Flat Type E Planning Outline

Drawing status FOR COMMENT

Project Name County Flats, Sandfields
Project Ref OAD_5174
Drawing Ref 1232
Drawing Name Flat Type E02
Drawn By WS
Date 12.05.2021

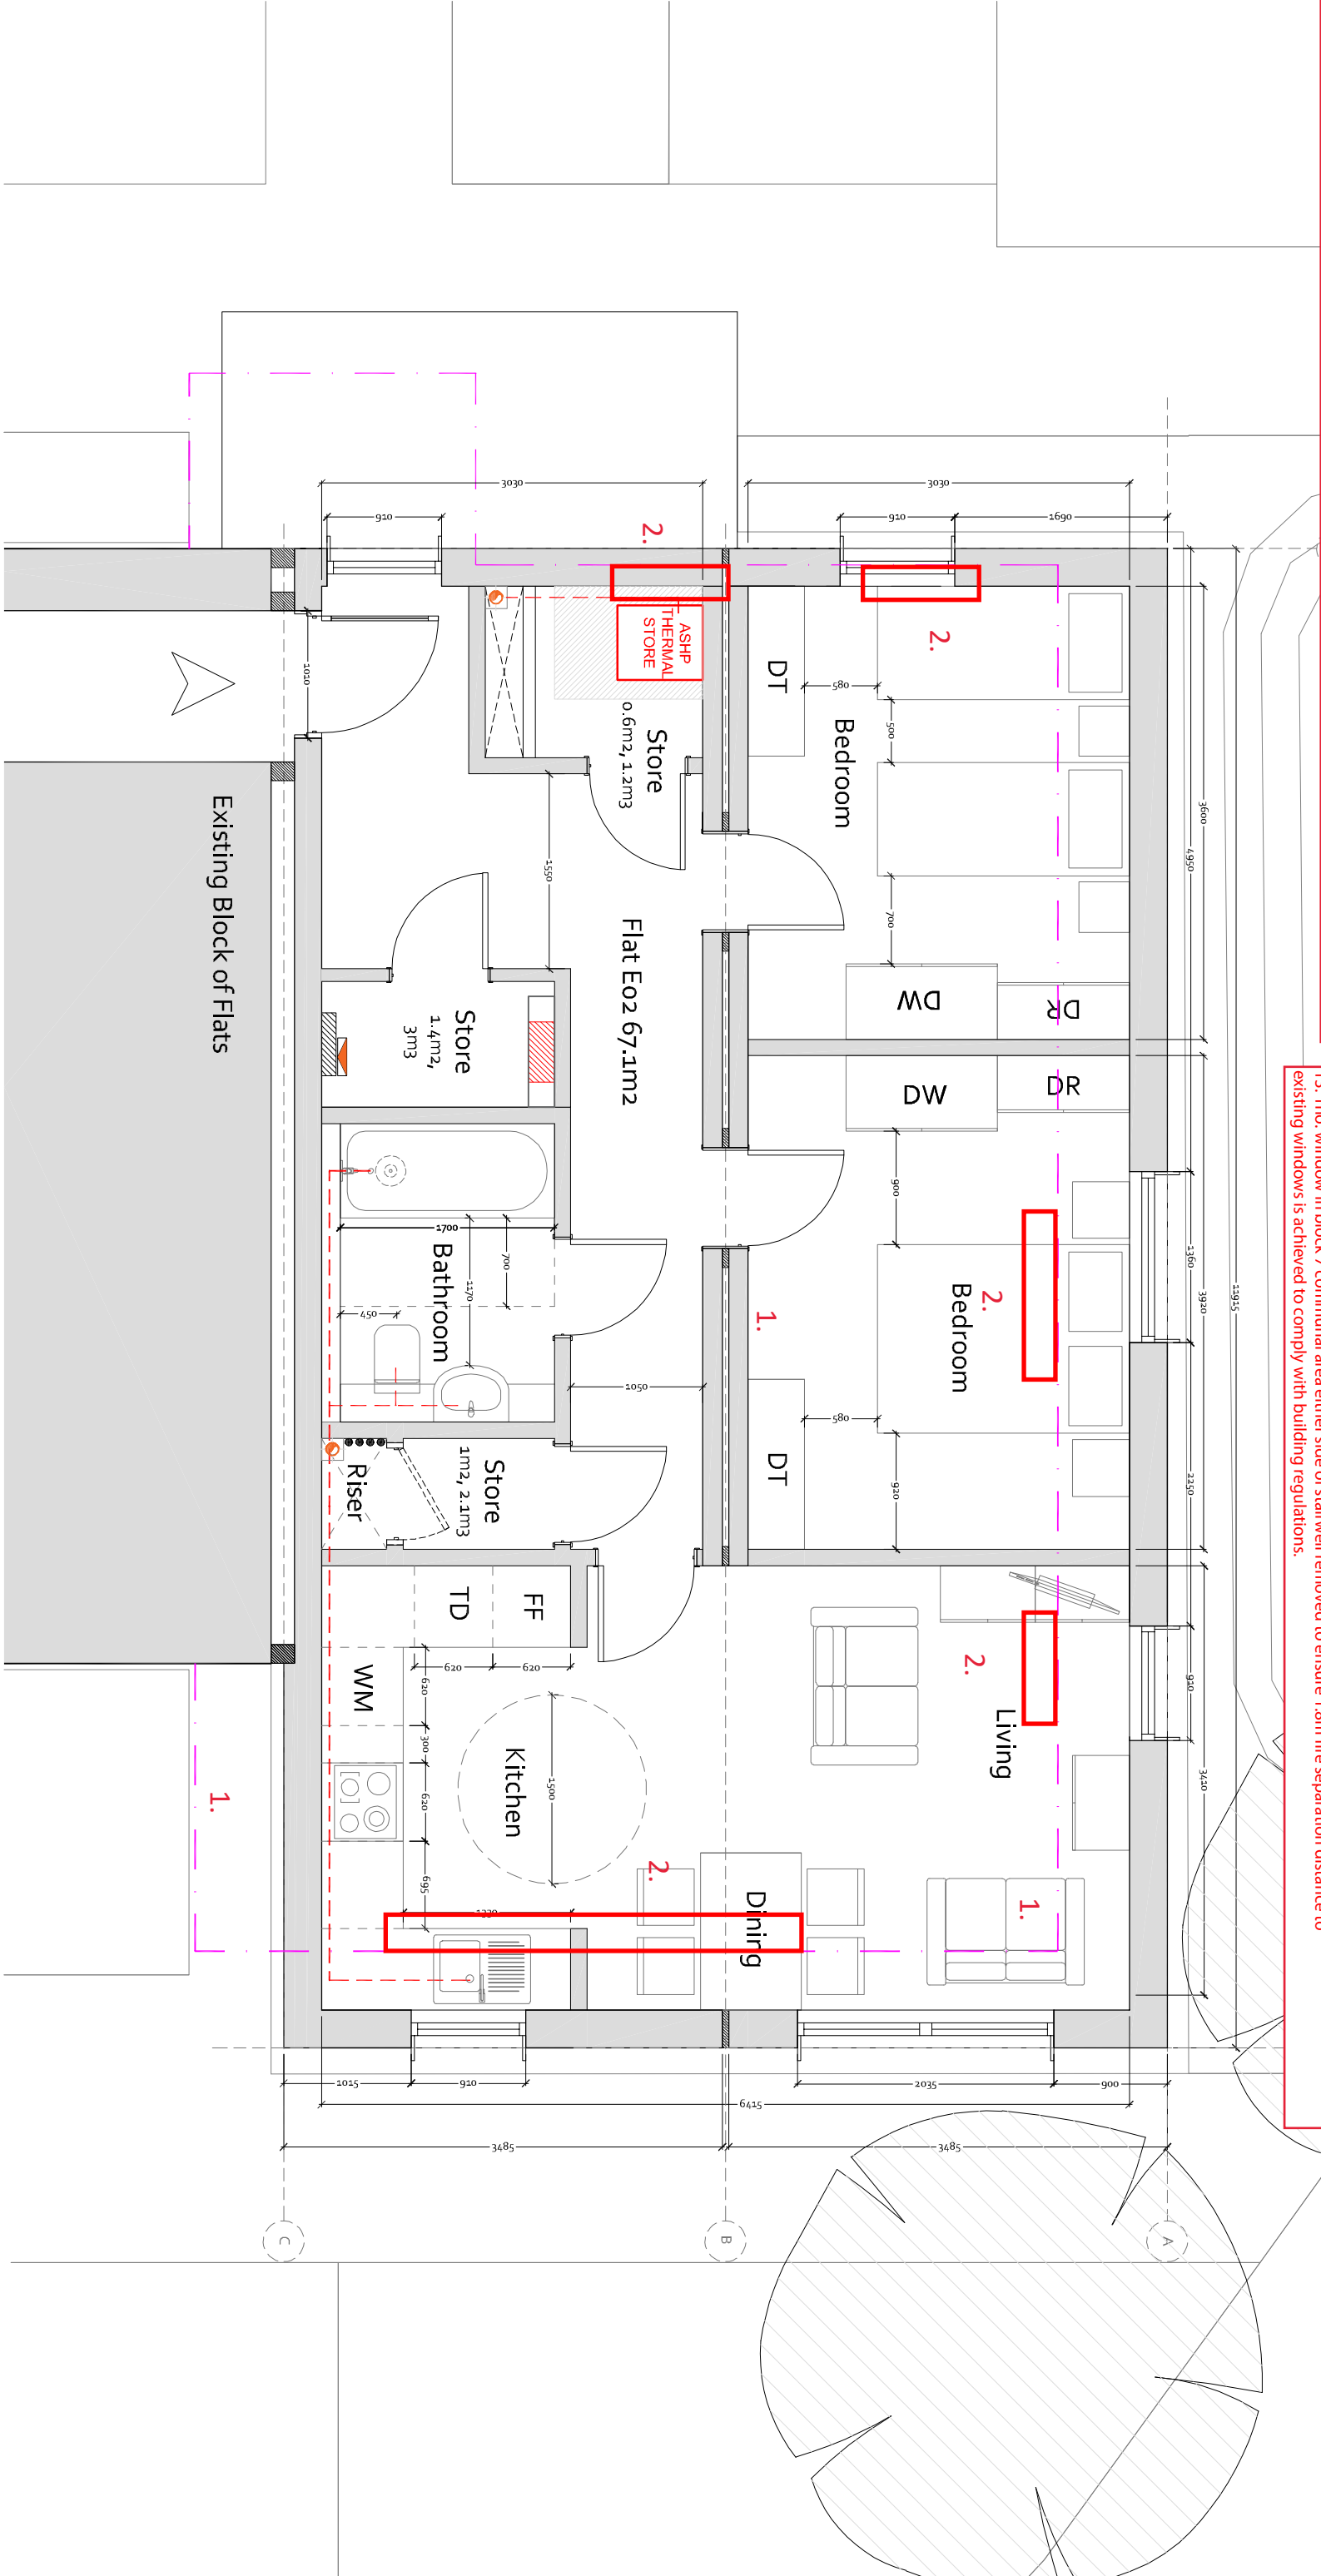
- DESIGN CHANGES
1. Modular end links re-positioned slightly off existing buildings, with the party wall straightened and porch projections aligned with this wall, to ensure modular construction can be achieved off site.

2. Windows have been slightly re-positioned to the new build to suit the structural design of the modular units and the constraints of the timber frame.

3. Parapet to modular end blocks have been lowered by approx 900mm to comply with the structural wind loadings and timber frame design.

4. Corner windows have been removed and replaced with 2no. Windows on either corner, again due to the structural and timber frame design of the blocks.

5. PV panels have been omitted from the end modular units to suit the structural and timber frame design of the blocks.

6. Ground floor Juliet balcony added to existing flats to provide better security whilst ensuring the open areas remain as communal spaces.
7. Air source heat pump external louvre enclosure amended to be single storey over entrance canopy to end link blocks.

8. External air source lowered enclosure handed to provide internal riser/access requirements for maintenance.
9. Buggy/cycle store added to block 6 and 7 parking courtyards.

10. Bin stores slightly re-positioned to suit existing drainage runs, with bin store near block 6 amended in size to suit located of bedroom window.
11. Footpaths amended to be Tarmac.

12. Windows in communal area to the linked blocks made narrower to ensure 1.8m fire separation distance to existing windows is achieved to comply with building regulations.

13. 1no. window in block 7 communal area either side of stairwell removed to ensure 1.8m fire separation distance to existing windows is achieved to comply with building regulations.
